**Economic Commission for Europe****Inland Transport Committee****World Forum for Harmonization of Vehicle Regulations****Working Party on Lighting and Light-Signalling****Eighty-fourth session**

**Simplification of lighting and light-signalling UN Regulations:****UN Regulation No. 149 (Road illumination devices)****Proposal for Supplement [12] to the 01 series of amendments  
to UN Regulation No. 45****Submitted by the Informal Working Group on Simplification of  
Lighting and Light-Signalling Regulations\***

**Figure**  
Diagram of Measuring Points on a Screen

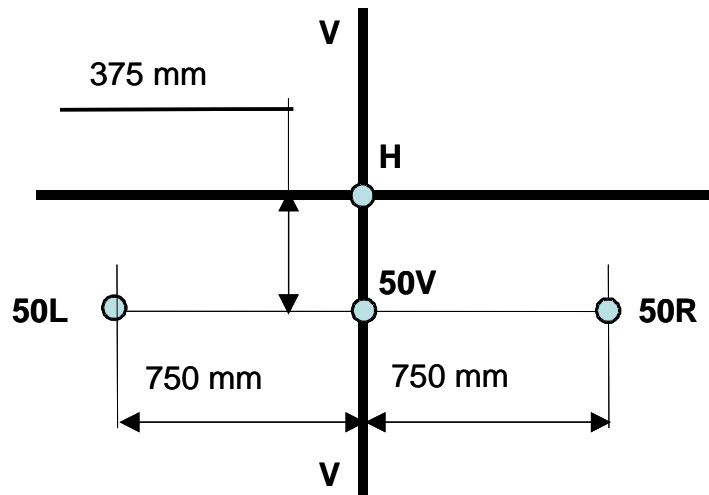
Paragraph 7.1., *amend to read:*

“7.1. The efficiency of the cleaner shall be tested in accordance with the requirements of Annex 4 to this Regulation. The cleaning efficiency at the points on the measuring screen which are specified below shall, after every cleaning period, amount to at least 70 per cent for the principal passing beam lamp and also 70 per cent for the optional driving lamp; in case of an AFS this provision applies to the photometric test procedures as defined in Annex 9 to Regulation No. 123 **or in Annex 4 to Regulation No. 149** from those lighting units in the neutral state indicated in paragraph 6.1.1. above. In the case of a headlamp (Regulation No. 98 or 112 **or classes A, B or D of Regulation No. 149**) providing bend lighting, the headlamp shall be set for the test in a straightforward direction.
